VARIEZE PLANS CHANGES

LONG-EZ PLANS CHANGES

SOLITAIRE PLANS CHANGES

REVISED FIGURE 5-1

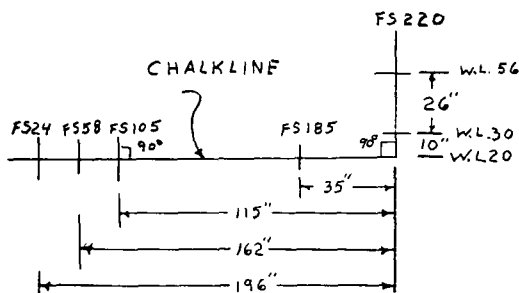
SPC #30 Section I, Chapter 5. The overview calls for the right fuselage half to go down into the fixtures which are setup on the floor. But the rest of the chapter calls out the left half. Although either half would work, it is probably simpler to put the right half in the fixtures because this is the half with the double joggle and cleanup of excess micro would be simpler. In order to put the right half in the fixture, figure 5-1 would need to be reversed as shown.
